1277A730 & 1277A740 ALTERNATORS

Upgraded to 155A !

NEW PRODUCT

1277A730 / 1277A740

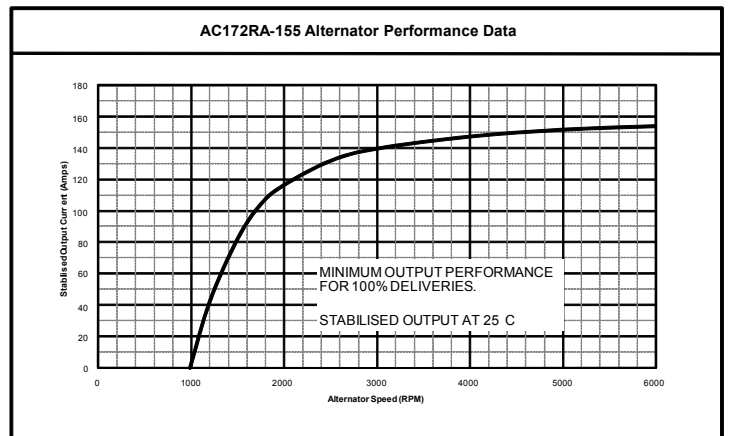
- Upgraded from 140A to 155A
- Brand new, not reconditioned
- Direct drop-in replacement for 1277730 / 1277740
- Extensive testing to ensure quality and reliability

- The 140A 1277730 / 1277740 is no longer available.
- 1277A730 and 1277A740 are new **without** surcharge.
- Z1277A730 and Z1277A740 are exchange **with** surcharge. Older 140A (Z)1277730 / (Z)1277740 core are still accepted. (Core price remains unchanged)

Only the following items are unique to 1277A730 & 1277A740:

- Rotor = 6332-A1503
- Stator = 6332-A1500
- Rear end bracket = 6360-487
- Regulator = 1861774
- Brush box = 6360-380A
